LVL Handbook Europe Corrections for 1st edition

Page 126, clause 4.3.7:

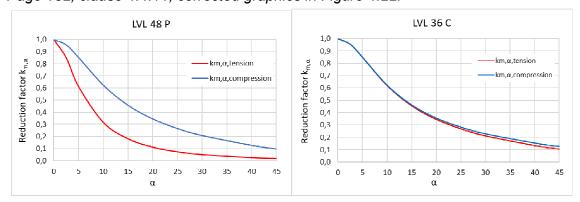
1st sentence: "The bending stresses at an angle α to grain should satisfy the following expression³²:"

Page 135, clause 4.3.12, corrected Figure 4.26.:

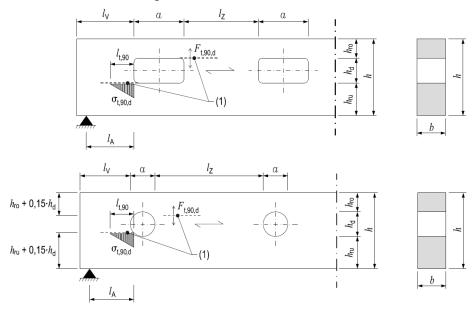
3^{rd} sentence: "Figure 4.22 shows the $k_{m,\alpha}$ factors as a function of the angle α "
